September 16, 2003 CPC

STAFF'S
REQUEST ANALYSIS
AND
RECOMMENDATION

03PR0368

Virginia Credit Union
(Virginia Credit Union Operations Center)

OVERALL
LANDSCAPE
DESIGN

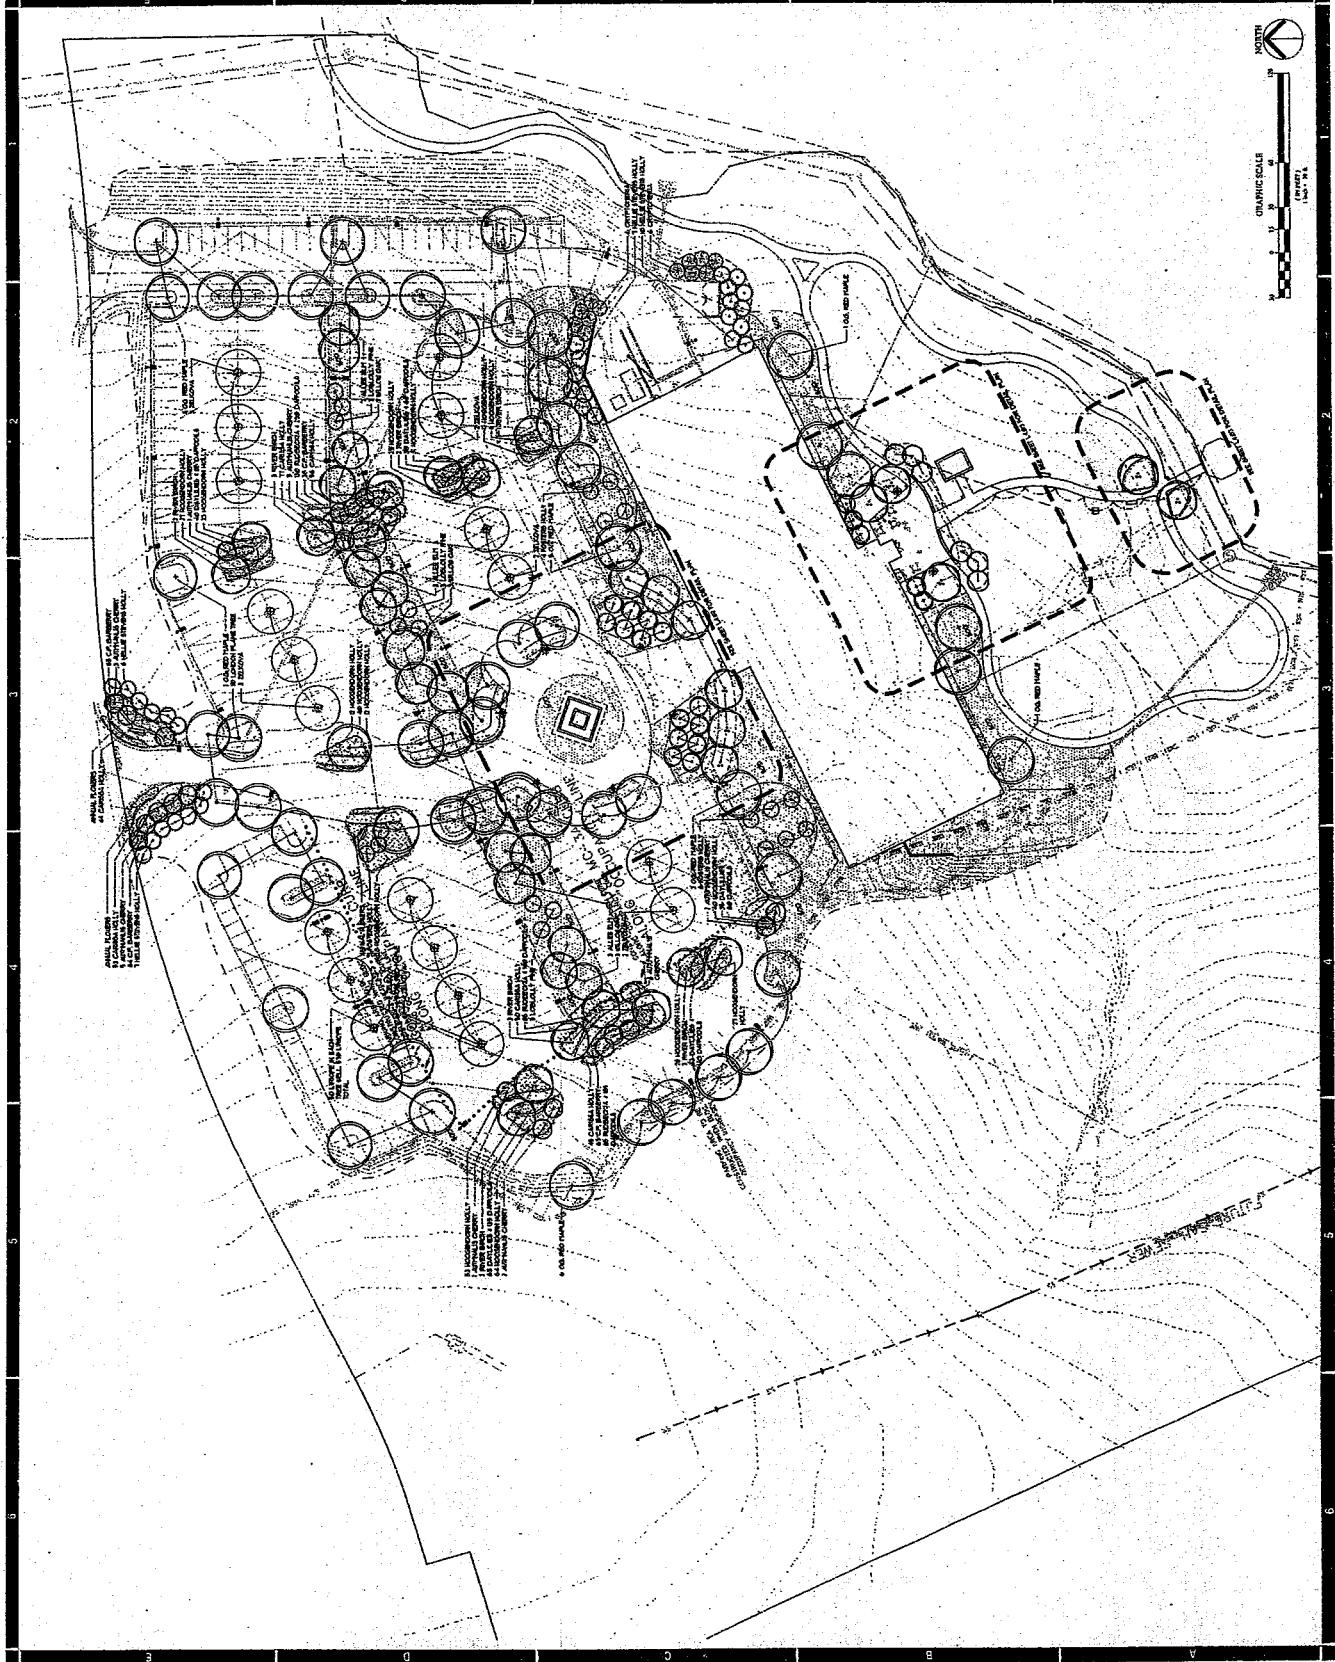
1. Label the twenty-five (25) foot "buffer area" along the proposed east-west road public road as required by the Textual Statement of Case 86S117.
2. Label the fifty (50) foot "buffer area" along Charter Colony Parkway (formerly known as Old Hundred Road) as required by the Textual Statement of Case 86S117.
3. Within each of the required buffer areas noted above, indicate existing groups of trees to remain and proposed landscaping. Provide the following note for each buffer area:

"Perimeter Landscape C is required within buffer areas. Existing plant material within the buffer areas may be credited toward landscape requirements as determined in the field by an agent of the Planning Department. If insufficient vegetation exists, additional plant material will be required to satisfy landscape requirements. Prior to occupancy of the building, call the Planning Department to schedule an inspection of existing plant material."

4. Indicate the pedestrian walkway on the landscape plan in conformance with the walk on the final approved site plan.
